# **A G E N D A**

## **Architectural Review Board**

**November 28, 2017**

*1857 Galena Avenue*

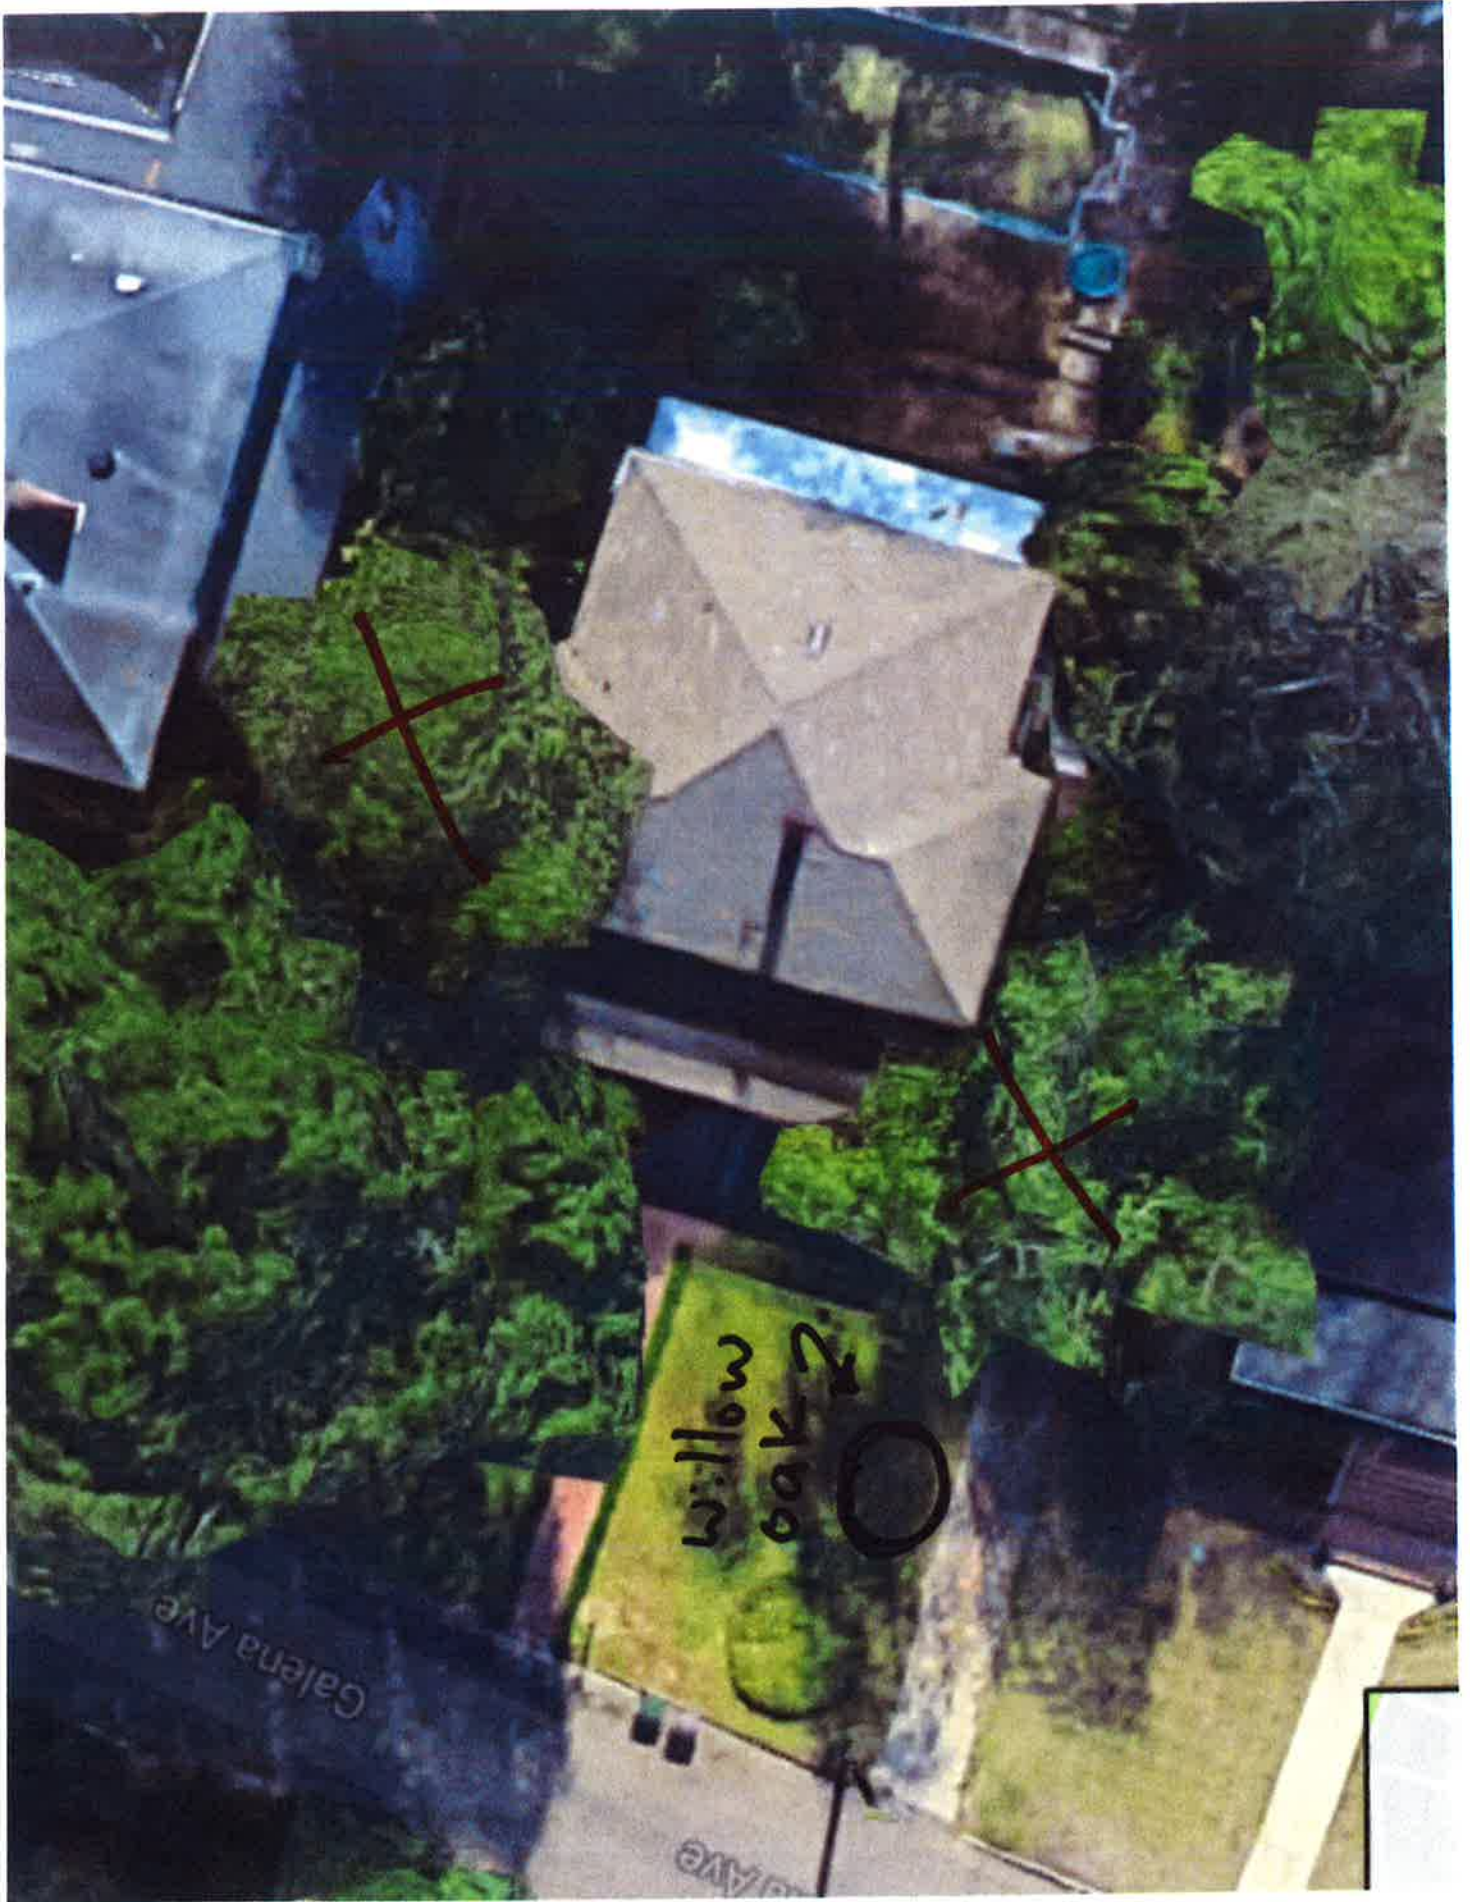
**REMARKS:** The petitioner is requesting permission after the fact for the removal of a 16”diameter black cherry tree. The petitioner proposes planting a 30 gallon willow oak at front right of house by the end of 2017.

- If approved subject to replacement, the Board should stipulate the tree be planted by the end of the next planting season (mid-March 2018) to give staff a better ability to enforce the decision.

3030 LeBron Road

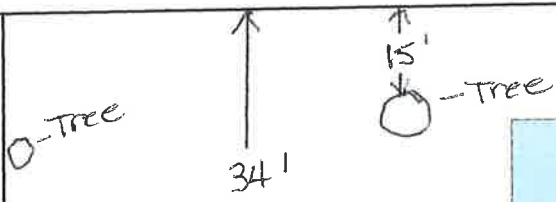
**REMARKS:** The petitioner is requesting permission to install a 14'x28' swimming pool with cool deck. No additional fencing or gates will be required to meet code.

- The only issues the Board has raised with pools in the past were in cases where mature trees were present. The Urban Forester feels if the dimensions provided in the site plan are accurate, the pool should not impact the existing rear yard tree.

475 S. Goldthwaite Street

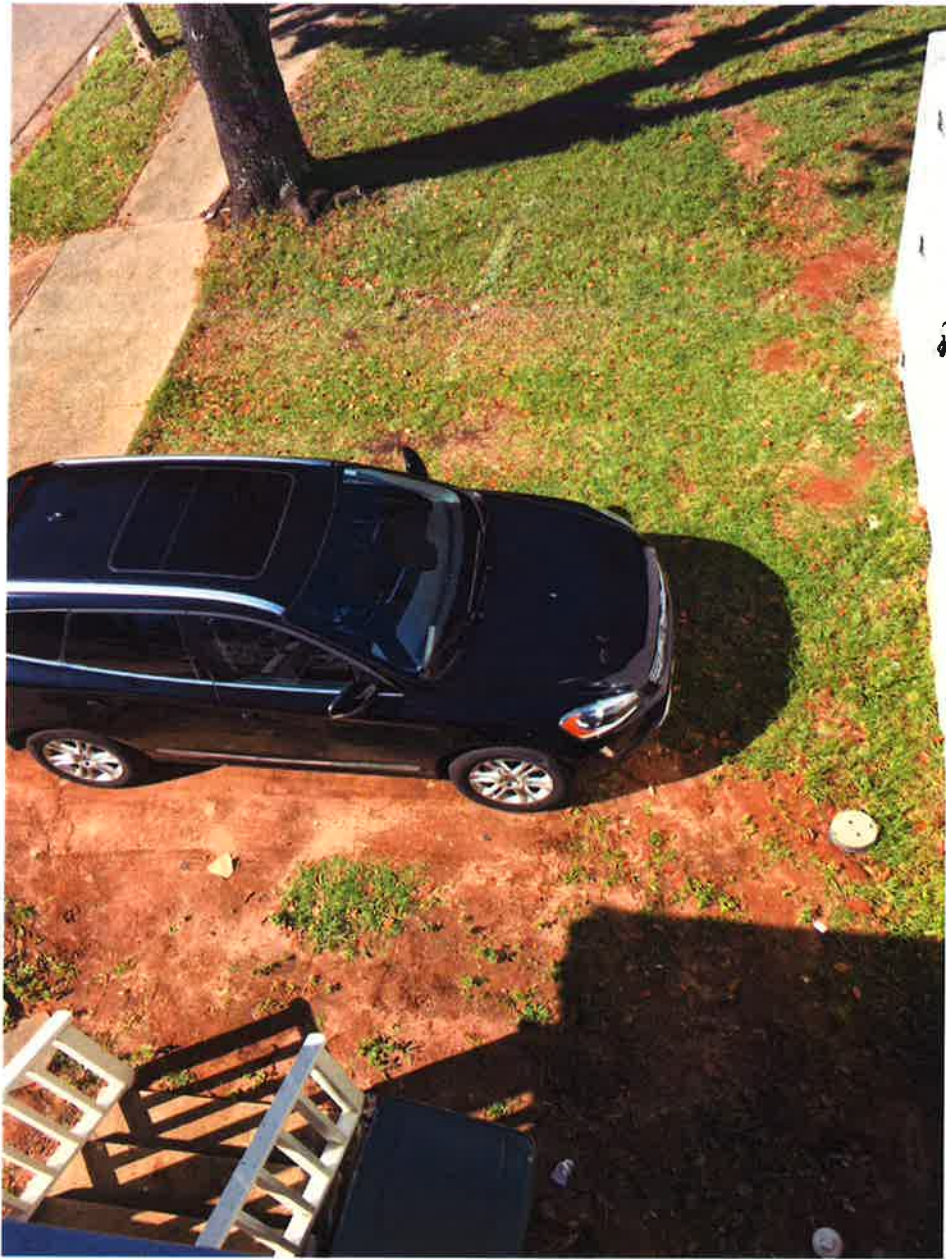
**REMARKS:** The petitioner is requesting permission to retain a 7' horizontal tongue and groove plank fence, an installed porch rail in the design illustrated, and two parking spaces that will be river rock bordered by a brick edge.

- Petitioner was asked to provide a site plan with dimensions to show the location and layout of the proposed parking area (the petitioner was provided with a scaled aerial and site plan), none was received while the agenda was being prepared.

- The Board has approved vertical board privacy fences, but has generally wanted the fence recessed from the front corner of the house so that it looks less like a fortification and more like a rear yard fence. This house is on a lot that fronts Goldthwaite, but as it is built, is situated at the rear of the lot, facing Mildred. It has virtually no rear yard.

- The Board has approved on horizontal board fence (St. Charles) but only after a great deal of discussion, as the Board had some trepidation with introducing a modern element at the street frontage. Privacy fences are not historic fences either but are routinely approved, the Board should consider whether or not the fence (design or placement) detracts from the overall character of the house.

2108 College Street

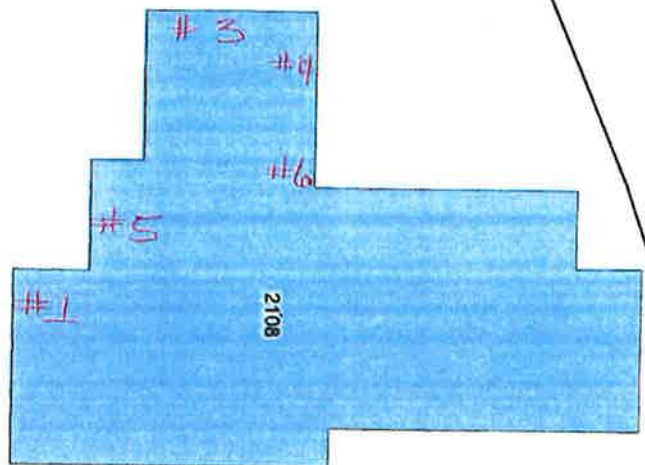
**REMARKS:** The petitioner is requesting permission to close several door and window openings on the rear (see illustrations and site plan indicating location of change) and proposes to install siding, feathered in, so it won't look like a patch.

1. Close side door to rear porch.
2. Fill in pool and sod
3. Close rear door and remove steps facing pool. Option 2 would replace door with a matching window.
4. Close off window in master bedroom. If filling with siding not an option, would propose installing shutters over window (there is already one done like that on the house) so it would read as a window but no longer function as one.
5. Close window at side of the house. If filling with siding not an option, would propose installing shutters over window so it would read as a window but no longer function as one.
6. Remove window at back of the house. If filling with siding not an option, would propose installing shutters over window (there is already one done like that on the house) so it would read as a window but no longer function as one.
7. Reduce size of front shutters to fit the windows.

Window option #2

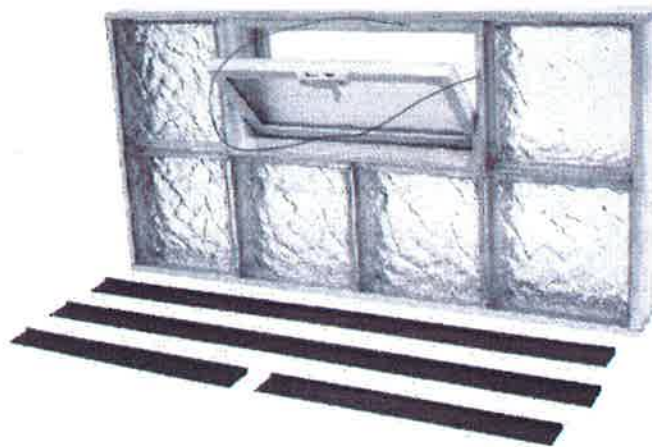
The petitioner would also like to add an east facing wall at the rear with glass block as illustrated. Option 2 would be a 1:1 window to match the adjacent window.

- Crushed run has been approved as a driveway material.
- The Board needs to consider if glass block is an appropriate window material, it is not one that I have seen come up for review in the last 11 years.

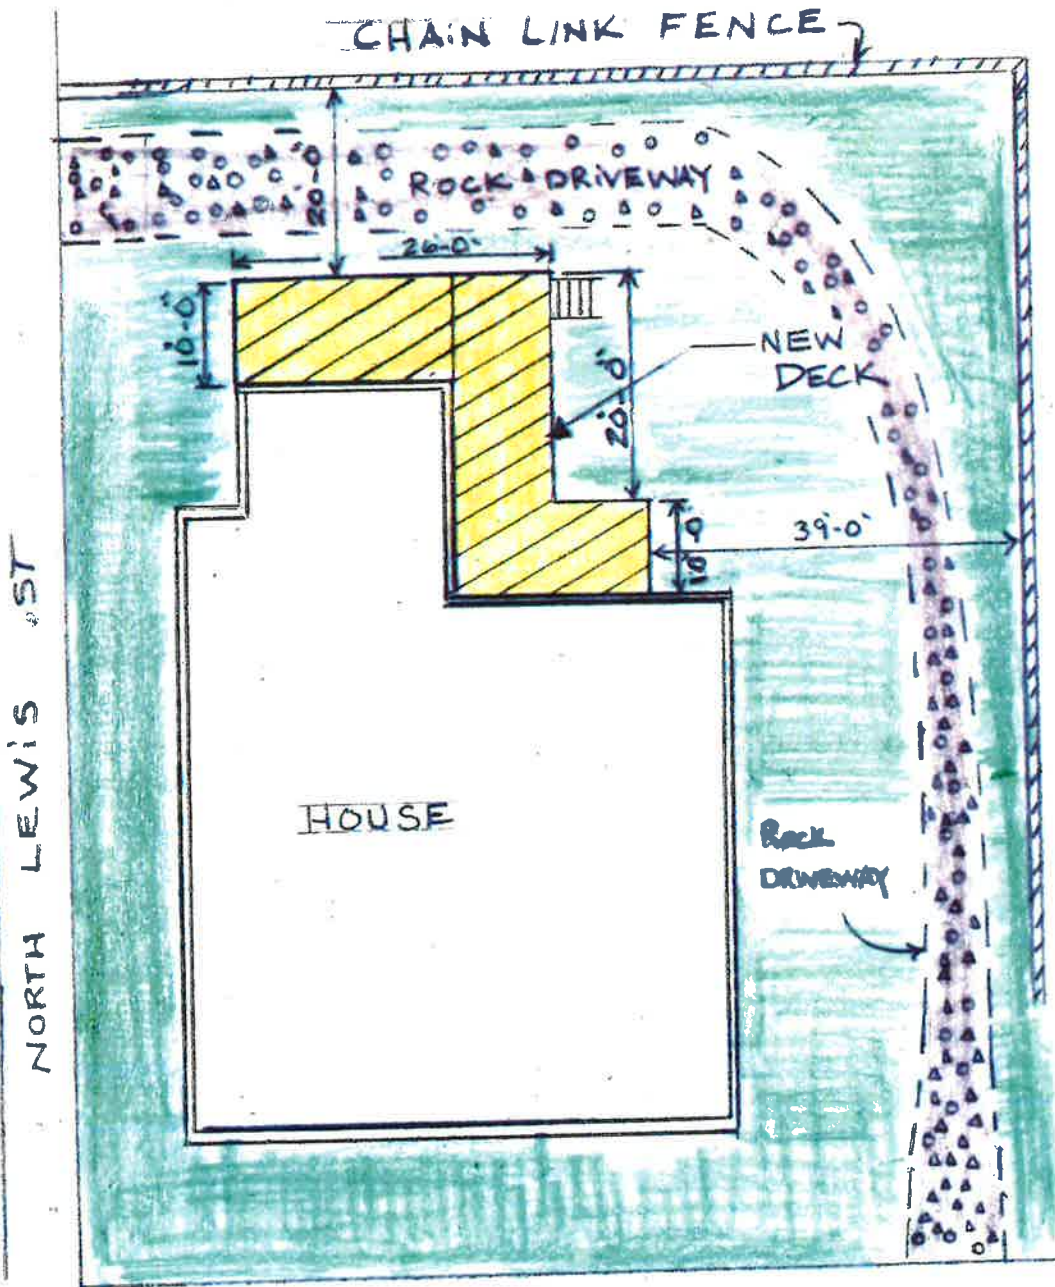
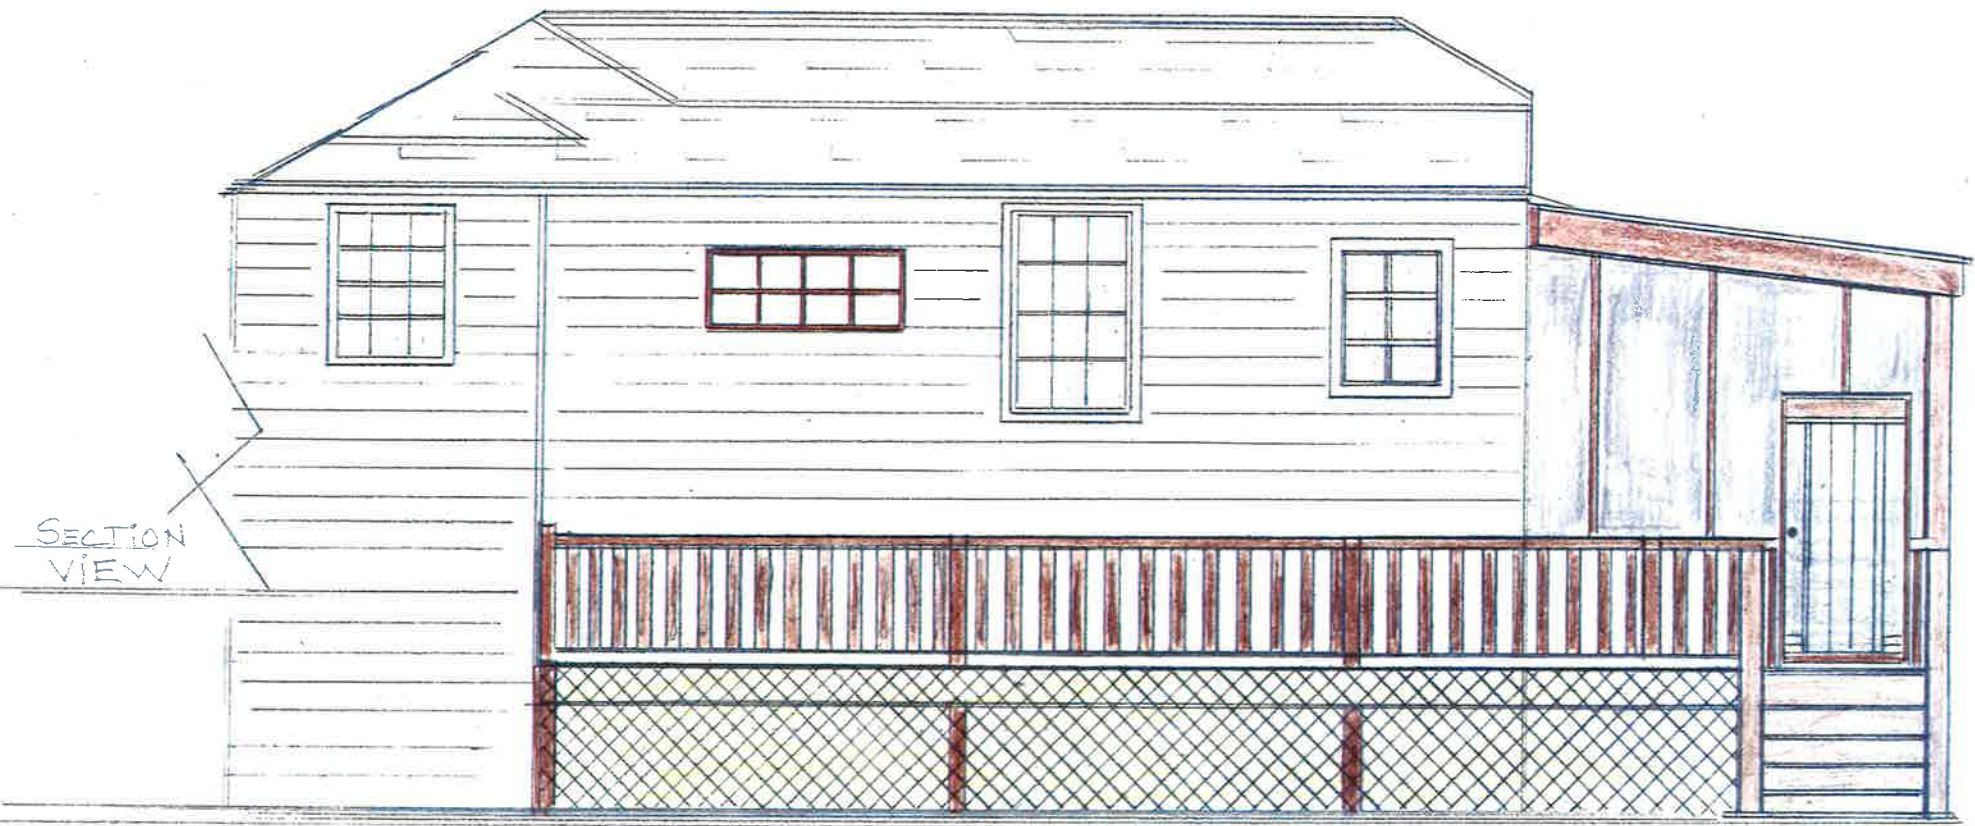
**REMARKS:** The petitioner is requesting permission to construct a rear deck and screened porch where illustrated (the footprint is smaller than the initial submission). The deck will be a "Z" shape that tucks into the ell, with the screen porch attached to the rear of the ell projection. The porch roof would be a dark gray rib steel panel or a 5 v crimp panel. The petitioner would also like to remove the window at the screened porch and make that opening a door opening with a 6 lite craftsman style door.
